NVM Express® Technical Proposal (TP)

Technical Proposal ID	TP6021 Status Reporting Enhancements
Revision Date	2023.06.11
Builds on Specification(s)	NVMe Management Interface Specification, Revision 1.2b NVM Express Base Specification, Revision 2.0b
References	TP6027 Reset Behavior Clarifications TP6033 MCTP Packet Timing

Figure 82: Controller Health Data Structure to Controller Health Status Changed Flags Mapping

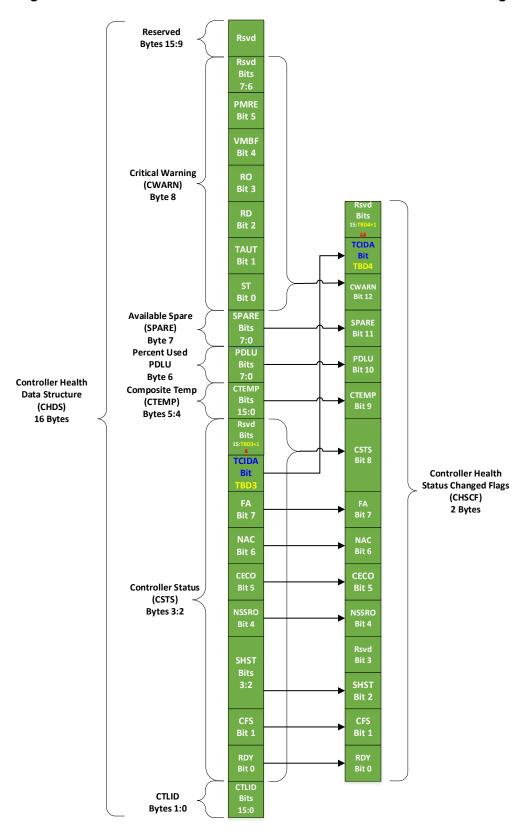
06	0	Namespace Attribute Changed (NAC): This bit is set to '1' when If the Namespace Attribute Changed bit in the Controller Health Data Structure transitions from '0' to '1', then this bit shall be set to '1'.
05	0	Controller Enable Change Occurred (CECO): This bit is set to '1' when If the Controller Enable Change Occurred bit in the Controller Health Data Structure changes state, then this bit shall be set to '1' transitions from '0' to '1'.

Bits	Reset	Description
04	HwInit	NVM Subsystem Reset Occurred (NSSRO): This bit is set to '1' when lf the NVM Subsystem Reset Occurred bit in the Controller Health Data Structure transitions from '0' to '1', then this bit shall be set to '1'.
03	0	Reserved
02	0	Shutdown Status (SHST): This bit is set to '1' when If the Shutdown Status field in the Controller Health Data Structure changes state, then this bit shall be set to '1'.
01	HwInit	Controller Fatal Status (CFS): This bit is set to '1' when If the Controller Fatal Status bit in the Controller Health Data Structure changes state, then this bit shall be set to '1' transitions from '0' to '1'.
00	0	Ready (RDY): This bit is set to '1' when If the Ready bit in the Controller Health Data Structure changes state, then this bit shall be set to '1' transitions from '0' to '1'.
